Sundry Print Report

Well Name: SERPENTINE 35-26 FED COM

Well Number: 16H

Type of Action: APD Change

Well: SERPENTINE 35-26 Fed Com 16H
County: Lea
Wellbore: Permit Plan
Design: Permit Plan #1

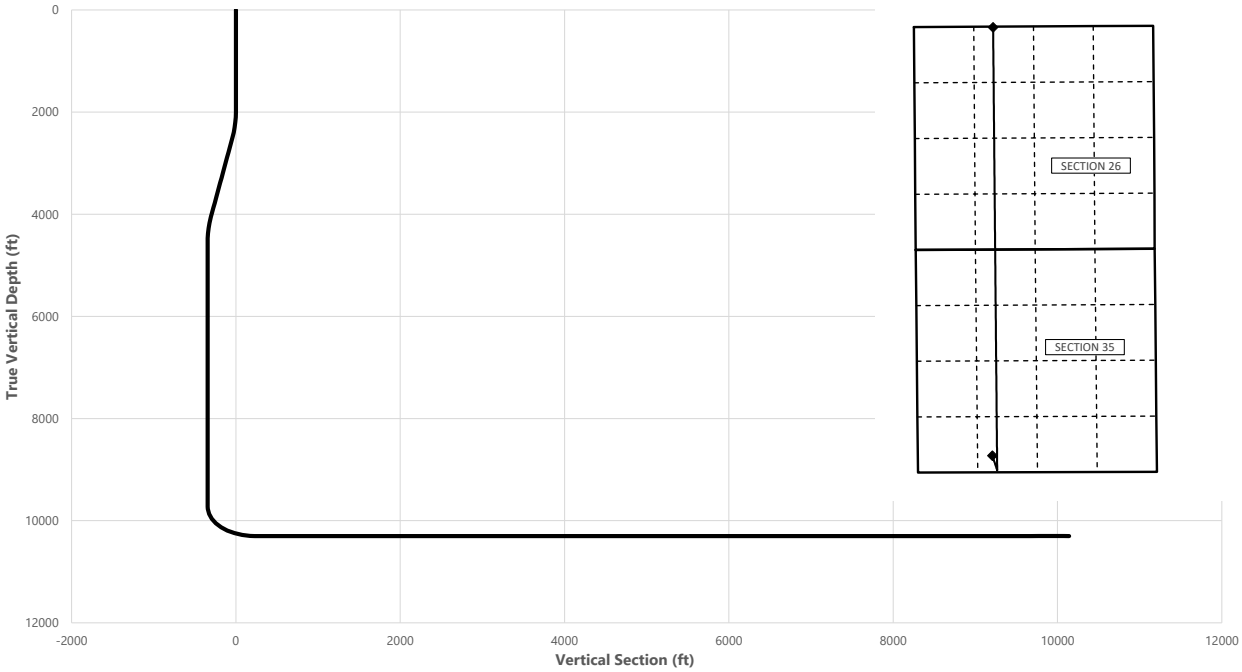
Engineering Only - Devon Energy Production Company L.P. respectfully requests the following changes to the approved APD:
BHL change from 20 FNL & 2178 FWL to 20 FNL & 1750 FWL, both 26-22S-33E.
TVD/MD Change from 9550/19,853 to 10,300/20,569
Casing program change: Intermediate, and Production Casing size and depth changes. Cement volume changes to accommodate casing change.
Break test and offline cement variance request included.
Please see attached revised C-102, spec sheets, and drilling & directional plans, and supporting documentation.

MD (ft)	TVD (ft)	Lat (°)	Long (°)	Section Footages
SHL	0.00	0.00	32.3420	-103.5465	396' FSL, 1648' FWL of Sec 35 in T22S, R33E
KOP	9755.97	9727.04	32.3410	-103.5461	49' FSL, 1750' FWL of Sec 35 in T22S, R33E
Point of Penetration	9009.93	8981.00	32.3412	-103.5460	100' FSL, 1750' FWL of Sec 35 in T22S, R33E
Exit	20488.67	10300.01	32.3697	-103.5461	100' FNL, 1750' FWL of Sec 26 in T22S, R33E
BHL	20568.67	10300.00	32.3698	-103.5462	20' FNL, 1750' FWL of Sec 26 in T22S, R33E
